## STAFF REPORT

### Community Planning and Preservation Commission Certificate of Appropriateness Request

<b>Case No.:</b>	<b>22-90200049</b>
Address:	730 28 <sup>th</sup> St N
Legal Description:	STRUTHER'S REPLAT LOT 2
Parcel ID No.:	14-31-16-85608-000-0020
Date of Construction:	1951
Local Landmark:	Kenwood Section – Northwest Kenwood Local Historic District (18-90300008)
Owner:	Sean O'Brien

**Request:** Review of a Certificate of Appropriateness for alterations at 730 28<sup>th</sup> St N, to include the following:

**Figure 3: Hardi-Board siding and vinyl sash windows installed as part of garage enclosure (applicant photo)**

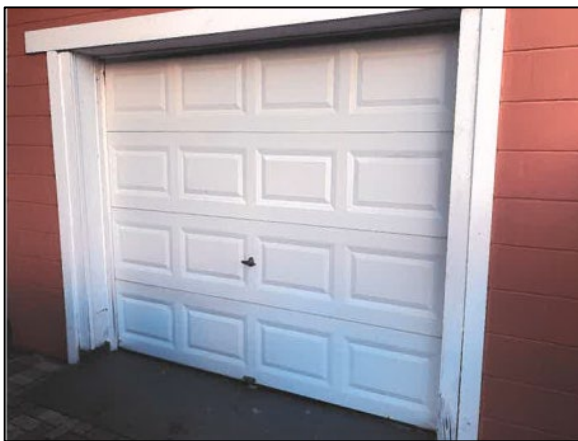
**Somewhat Inconsistent** An ideal approach to this garage enclosure would be to visually replicate a garage door from the exterior and minimize the visual impact of the new window openings.

**Generally consistent** The garage door that was removed was not historic material but did serve a historic function. The infill of the opening with horizontal Hardi-Board partially references a wood or horizontally banded metal garage door that would likely have been present in this opening historically. The vinyl sash windows detract from this reference but are not highly visible.

Based on a determination of general consistency with Chapter 16, City Code of Ordinances, staff recommends that the Community Planning and Preservation Commission **approve with conditions** the Certificate of Appropriateness request for the alteration of the property at 730 28<sup>th</sup> St N, a contributing property to the Northwest Kenwood Local Historic District, subject to the following:

Photo 5D - Fence Photo D  
East Elev - NE Corner of House

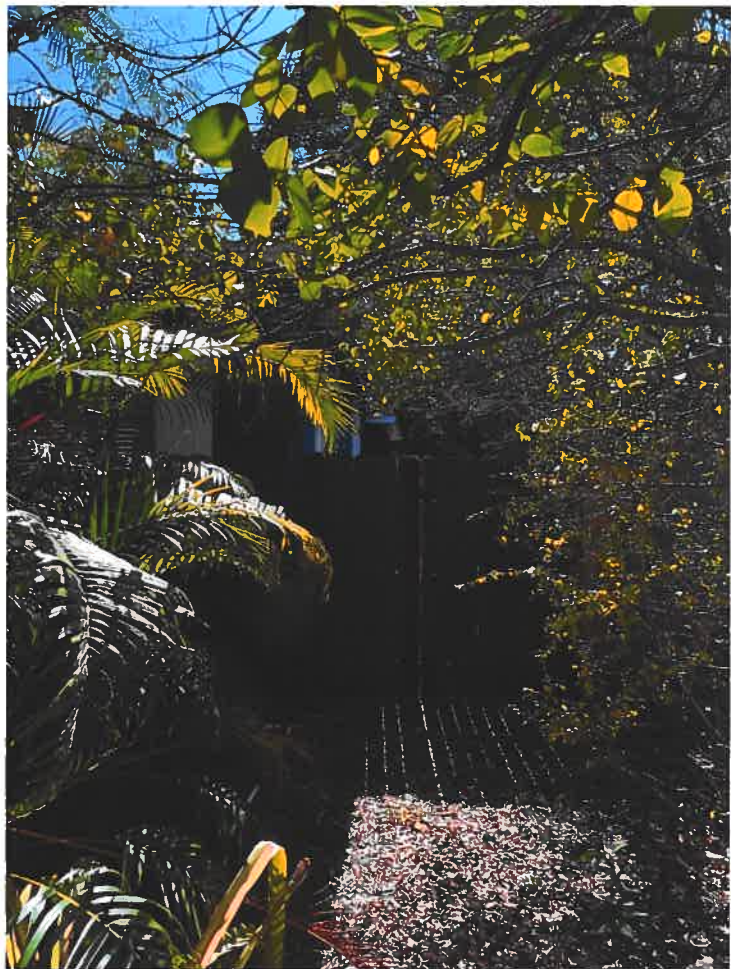
5. Fence: Your application shows horizontal wood fencing, which is generally considered to be too contemporary for Kenwood's pre-War urban landscape. I will be recommending a more traditional vertical-board fence. If that's the case, I'll most likely just leave it as is. However, I would like to see what other types of vertical fencing would be acceptable if I decide to replace it.

1. Wooden fencing will feature vertical boards and satisfy Zoning requirements for fence placement and height.
2. A historic preservation final inspection will be required.
3. All other necessary permits shall be obtained. Any additional work shall be presented to staff for determination of the necessity of additional COA approval.

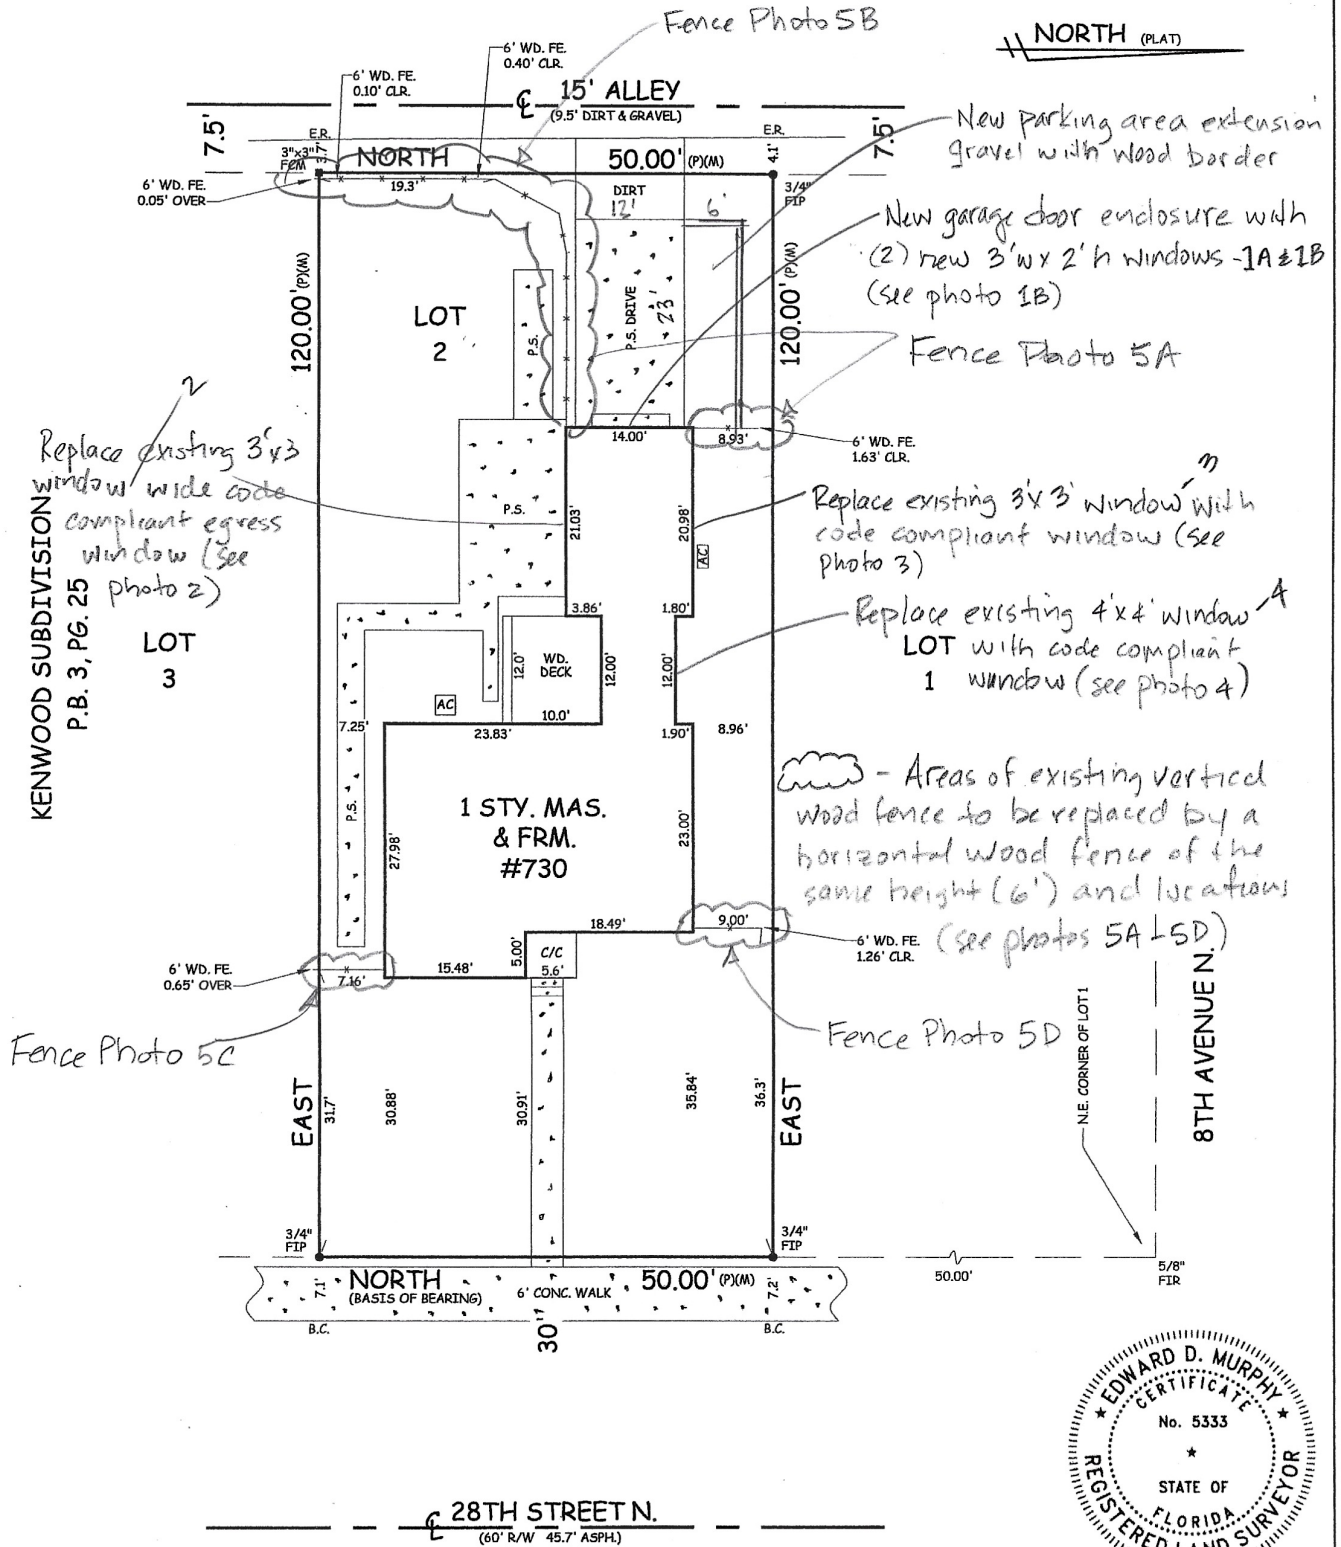
4. **Parking:** I'll be coordinating with Zoning throughout the process to make sure feedback is consistent. I believe you indicated you would be adding a parking spot for compliance. Please submit a site plan showing this change.

4. Parking: I'll be coordinating with Zoning throughout the process to make sure feedback is consistent. I believe you indicated you would be adding a parking spot for compliance. Please submit a site plan showing this change. Sorry about that, I thought I included it on the survey/site plan. See the attached revised site plan showing the expanded parking area. The existing paver driveway is 12'w x 23' d. I'll add a 6'w x 23'd area of gravel to the north of the existing pavers with a wood border. This will provide the two required 9' x 18' parking spaces.
